February 2025 Draft Lithium Valley Specific Plan

Public Review Comments

Section 1: Federal, State and Local Agencies

12. **5.3 Bicycle and Pedestrian Access, Pg 106**
    a. "Provide a connection from Niland to the Salton Sea via a Recreational Access Easement" & **Figure 5-8, Bicycle Network Map, Pg 107**

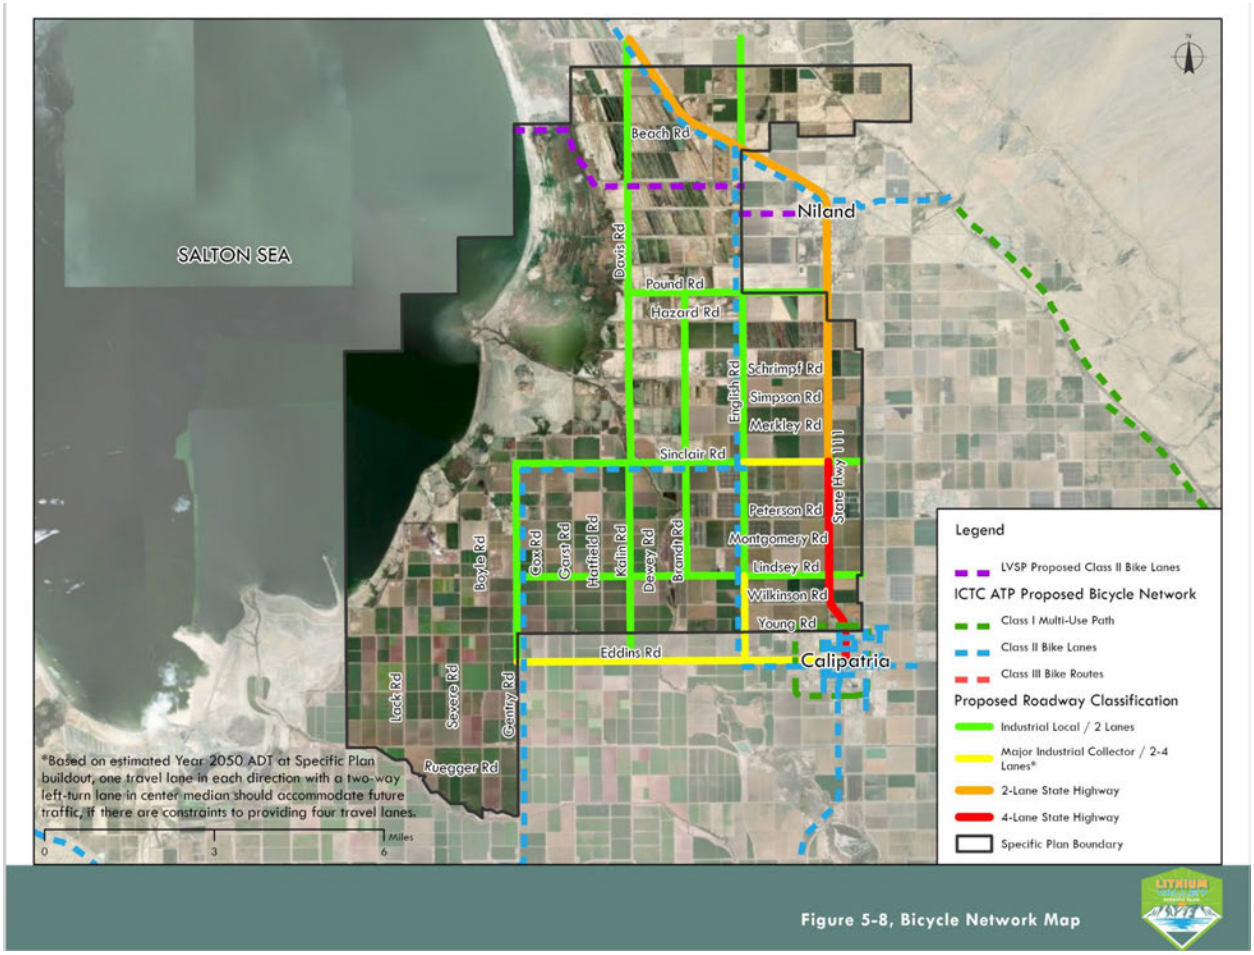
i. While this route could increase public recreation opportunities for the community, all proposed changes within the Wister boundary need to be approved by the appropriate staff at the CDFW, especially if they conflict with public hunting or endangered species conservation **Figure 7**.

13. **Figure 5-9, Rail Network Alternatives Map, Pg 110**

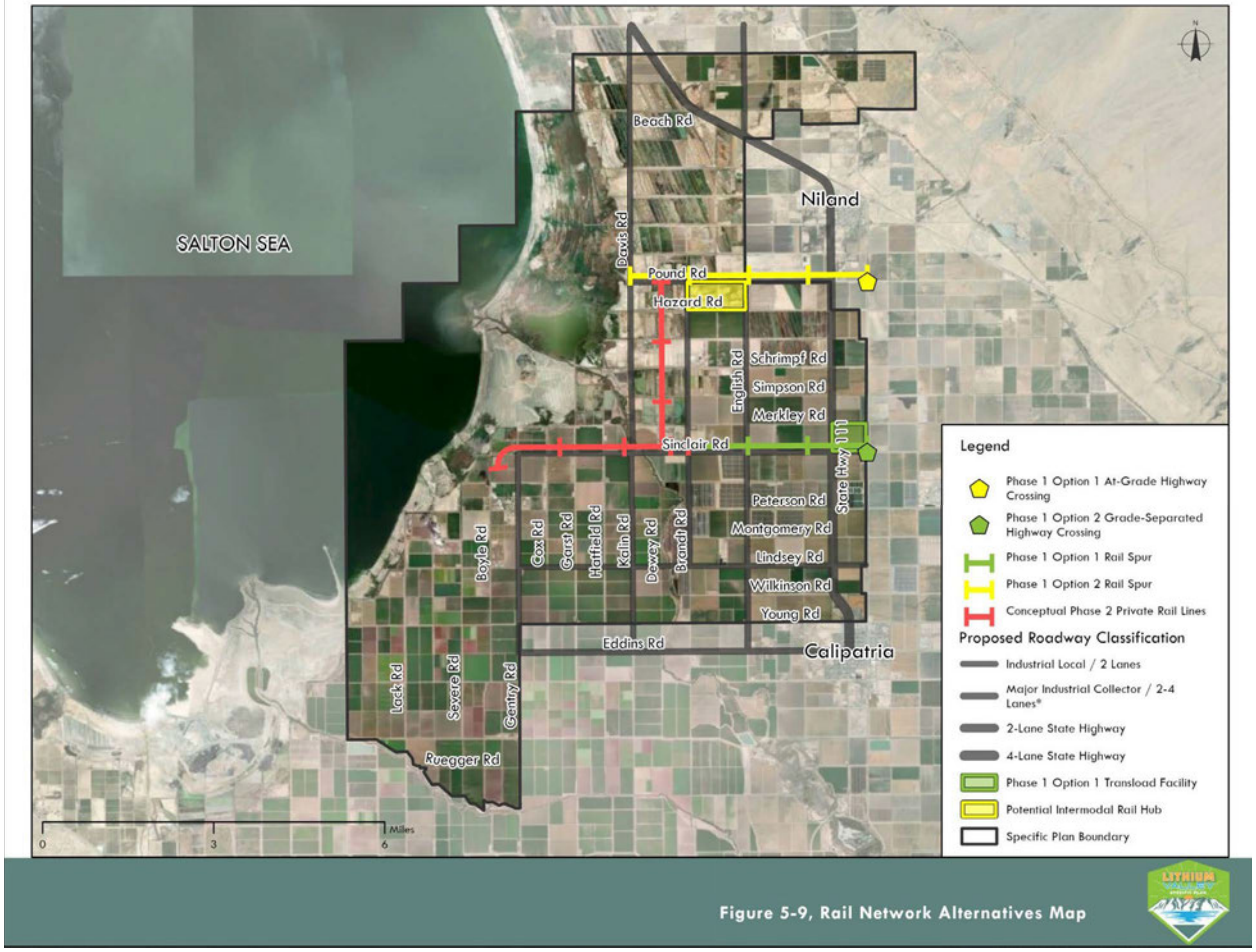
a. While Phase 1 Option 1 At-Grade Highway Crossing & Phase 1 Option 2 Grade-Separated Highway Crossing of the Rail Network Alternatives Map do not directly impact the Refuge lands, these plans will have a detrimental impact on the habitat quality of Wister. Any changes made on land within the Wister boundary or directly adjacent to it need to be approved by the appropriate staff at the CDFW.

b. Conceptual Phase 2 Private Rail Lines, as depicted within the figure, cuts through much of the Refuge Headquarters area, **Figure 1** & **Figure 5**, and effectively cuts off the Refuge's access to county roads if and when a train is traversing the line. While reducing the Refuge's access to county roads is not an issue, if rail traffic is sparse, it will be a huge detriment to the standard operation of the Refuge if the Potential Intermodal Rail Hub is established between Pound and Hazard Road. Additionally, a private rail line cannot be established on federally protected lands with the designation of wildlife conservation (National Wildlife Refuge System Administration Act of 1966). Additionally, building a private rail line through the Refuge Headquarters would displace all Refuge staff and effectively shut down all operations.
